Mask Set Errata for Mask 1M21A

This mask set errata applies to the mask 1M21A for these products:

- MC9S08RE16
- MC9S08RE8
- MC9S08RD16
- MC9S08RD8
- MC9S08RC16
- MC9S08RC8

Case 1

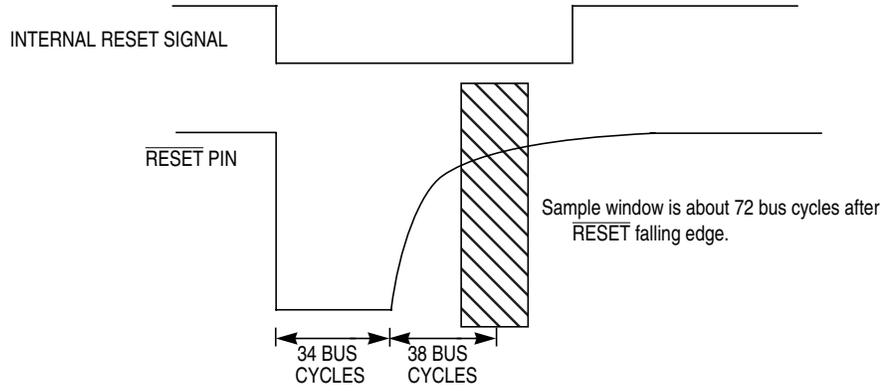
If a falling edge is detected on the external reset pin at either of two sample points, the MCU will cease operation and will recover only after a power-on reset.

Case 1 — After detecting a reset signal, either internal or external, the internal reset circuit latches the cause of the reset, forces a low level on the external $\overline{\text{RESET}}$ pin for about 34 bus cycles, releases the pin, and samples the pin level about 38 bus cycles later.

To avoid multiple edges on the $\overline{\text{RESET}}$ pin due to switch contact ringing or EMC noise, eliminate any voltage bounce through RC filtering. A 0.1 μF capacitor to ground and an external 4.7 k Ω to 10 k Ω resistor to V_{DD} works well to ensure noise suppression.

Case 2

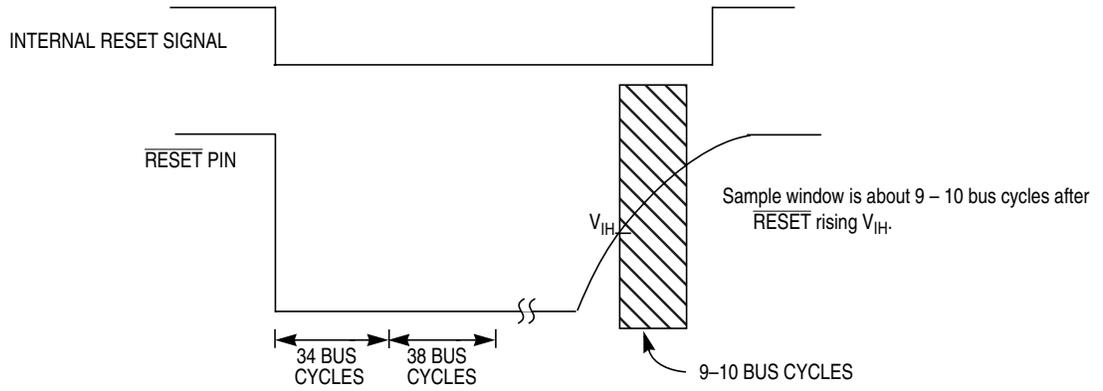
Case 2 — After remaining in reset for an extended period of time due to an externally applied low level on $\overline{\text{RESET}}$, the internal reset circuit will sample the pin level about 9 to 10 bus cycles after the pin raises above its V_{IH} level.

In addition to RC filtering, avoid spurious edges on the $\overline{\text{RESET}}$ pin caused by external active circuitry such as low voltage detectors and watchdog components. Do this by ensuring that external circuitry cannot drive $\overline{\text{RESET}}$ low within 10 bus cycles of the release of $\overline{\text{RESET}}$.
